# PHILADELPHIA ELECTRIC COMPANY

References: Docket No. 50-277, Application for Amendment of Facility Operating License DPR-44, submitted 2/19/82 with respect to the Peach Bottom Atomic Power Station Unit 2 Reload 5 Application.

This letter serves to provide additional information with respect to the Peach Bottom Unit 2 Application for Amendment of Facility Operating License as a result of an error discovered in the current version of the ODYN transient computer code which was used for performing the Peach Bottom 2 Reload 5 (Cycle 6) pressurization transient analyses. Results of these analyses were reported in the General Electric document Y1003J01A34 which was previously submitted at the time of the referenced Reload 5 license amendment application.

SUBJECT: Peach Bottom 2 Reload 5 (Cycle 6) Reload Licensing  
Analysis Error

FIGURE 3.5.K.1 MCPR OPERATING LIMIT vs  $T$

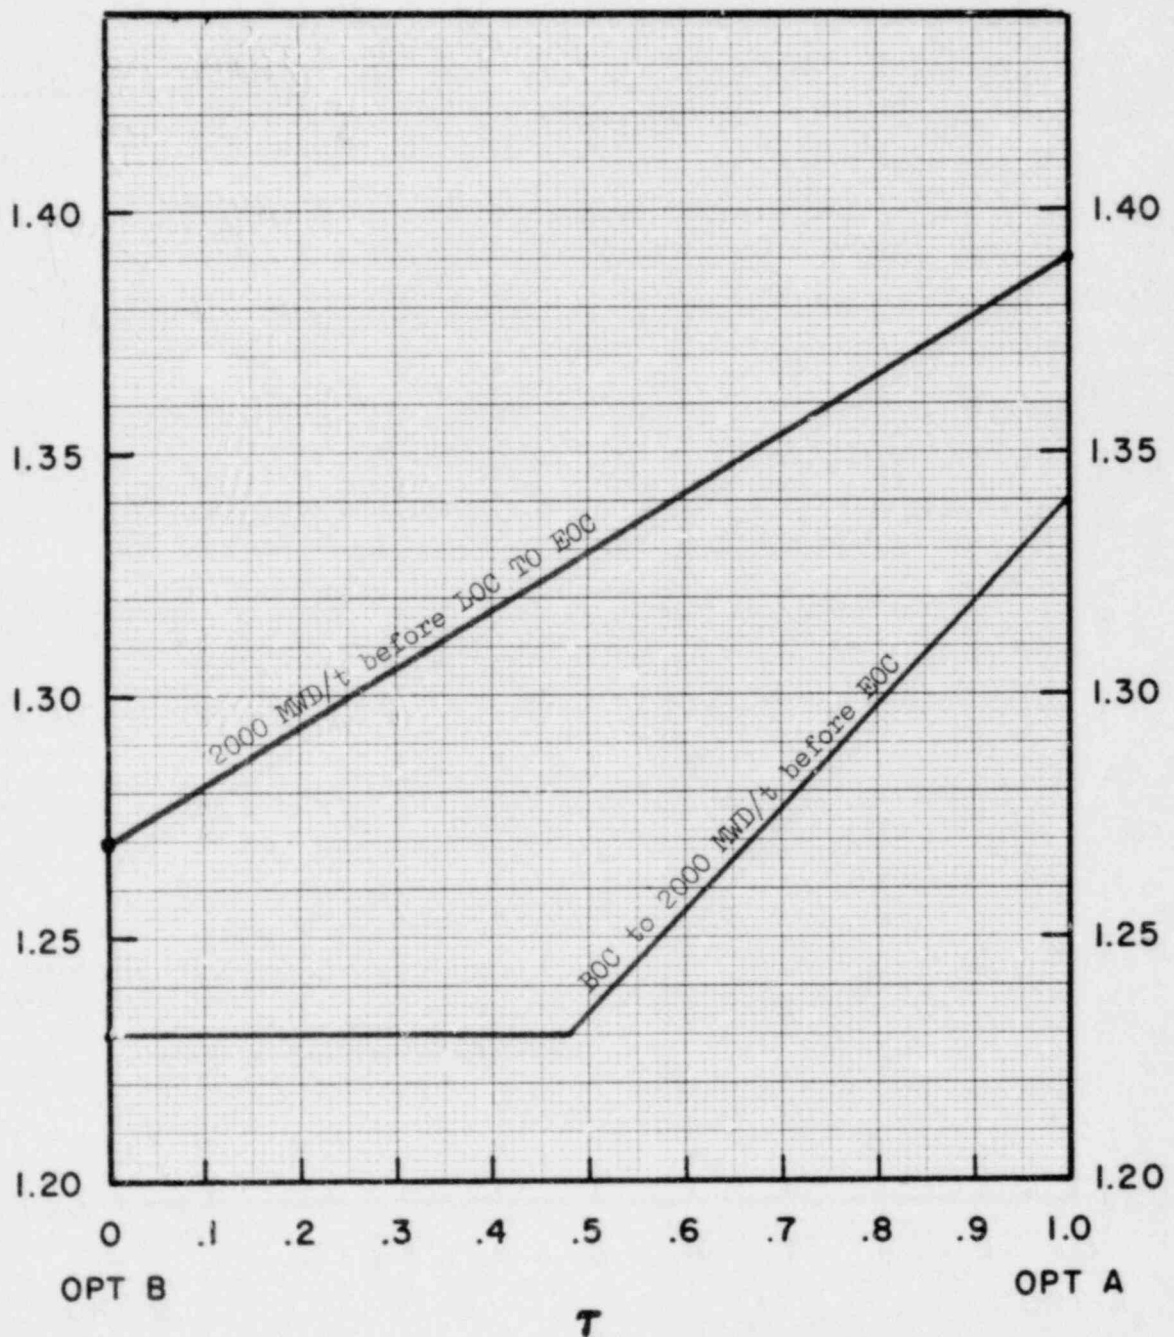
GE correspondence provides a description and explanation of the analysis error, including a table of revised cycle MCPR values for pressurization events. Philadelphia Electric has appropriately revised and enclosed copies of pages 133d, 133e, 142, 142a, and 142b of the Peach Bottom 2 Reload 5 Facility Operation License Amendment Application.
